D206-642-241
Job Sheet 192253

Part Name: Replacement Skidtube, High Gear with Standard Wearplates Fits LH or RH

DRAWING NO. D2650	TITLE 206/407 SKIDTUBE ASSEMBLIES	REV. F	DART AEROSPACE LTD ENGINEERING ORDER		D.E.O. NO. D2650-F-1	SHEET NO. SHEET 1 OF 1	SCALE NTS	
DRAWN 12.10.12	CHECKED A.P. 12.10.22	MFG. APPR. 12.10.22	APPROVED 12.10.22	DE APPR. 12.10.22

CHANGE C'BORED WELDED CROSSBOLT SPACERS TO SWAGED SPACERS

AMENDMENT TO DETAIL B
NOT TO SCALE

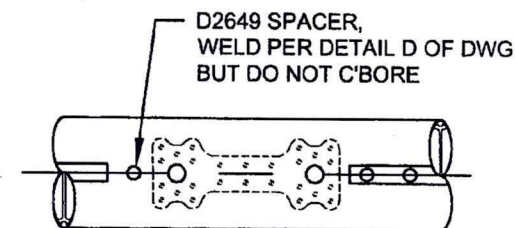
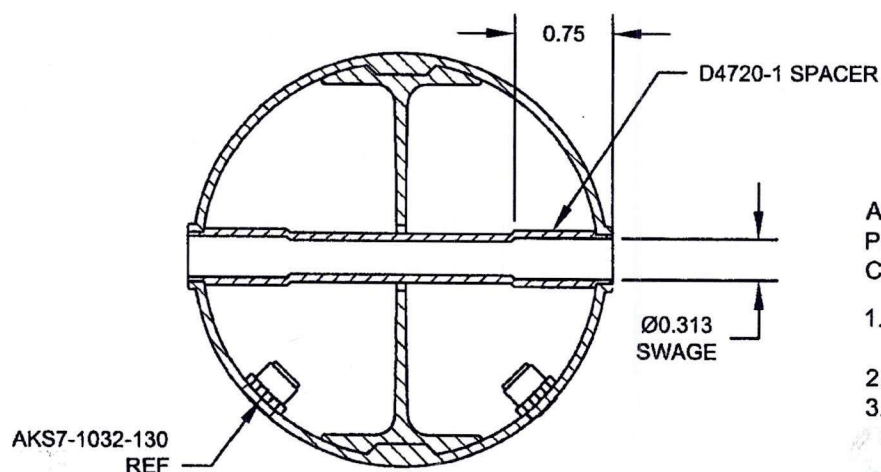
ADD DETAIL G BELOW, WHICH IS THE SAME SECTION VIEW AS DETAIL D OF DWG.

C'BORED HOLES ARE **NOW SWAGED** PER DETAIL G BELOW. FOR THE Ø0.375 HOLE THAT IS NOT C'BORED, WELD PER DETAIL D OF DWG (SEE AMENDED DETAIL B FOR REFERENCE).

AFTER DRILLING AND BENDING ASSEMBLY
PERFORM THE FOLLOWING FOR Ø0.375 HOLES THAT ARE
CURRENTLY C'BORED:

1. INSERT D4720-1 SPACER, 16 PL (-1) OR 17 PL (-3) OR 19 PL (-5) OR 23 PL (-7)
2. SWAGE TO Ø0.313 X 0.75 DP PER QSI 002
3. TRIM / GRIND FLUSH PER QSI 002
